APPLICATION NO.	FILING DATE	FIRST NAMED INVENTOR	ATTORNEY DOCKET NO.	CONFIRMATION NO.
10/585,986	07/13/2006	Soichiro Kemmochi	SH-0062PCTUS	1706
21254 7590 12/22/2008 MCGINN INTELLECTUAL PROPERTY LAW GROUP, PLLC 8321 OLD COURTHOUSE ROAD SUITE 200 VIENNA, VA 22182-3817				
EXAMINER JENNINGS, STEPHANIE M				
ART UNIT		PAPER NUMBER		
4135				
MAIL DATE		DELIVERY MODE		
12/22/2008		PAPER

Office Action Summary

DETAILED ACTION

FIG. 6

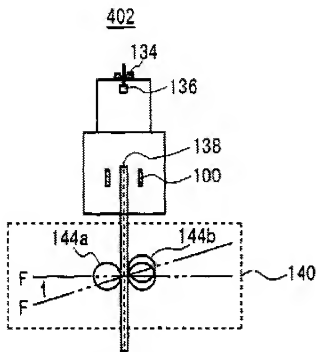
13. Limitations from claim 1, A method of elongating optical fiber base material (102, figure 5, not shown) comprising: heating and softening base material ingot (102) in such as an electric furnace (176); drawing said ingot (102) with a pair of pinch rollers (144a, 144b, figure 10); and elongating the ingot (102) to make base material rod having a smaller diameter than said ingot (102), wherein a roller groove having a curvature radius which is larger than the outer diameter, and wherein the facing roller grooves (144a, 144b) respectively formed on the surfaces of a pair of said pinch rollers (142, figure 6) nip and draw said base material rod (column 2, lines 26-34).

15. Limitations from claim 7, the apparatus for elongating optical fiber base material (102) according to claim 5, wherein the surfaces of said pinch rollers (142) are wound and fixed woven fabric made of heat-resistant material to prevent said pinch rollers (142) from directly contacting to base material rod made of metal (column 10, lines 26-28 and 36-41).

FIG. 10

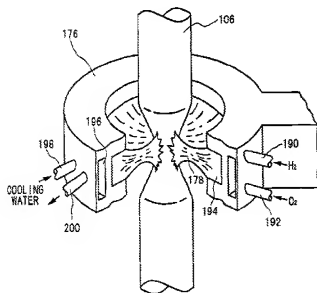
14. Limitations from claim 5, an apparatus for elongating optical fiber base material (102), which heats and softens base material ingot (102) in such as an electric furnace (176); draws with a pair of pinch roller (144a or 144b); and elongates to make base material rod having a smaller diameter than the ingot (102), comprising said pinch rollers (142) which are made of metal, and respectively have a roller groove (144a, 144b) having a curvature radius which is larger than the outer diameter of said base material rod (column 2, lines 26-34).
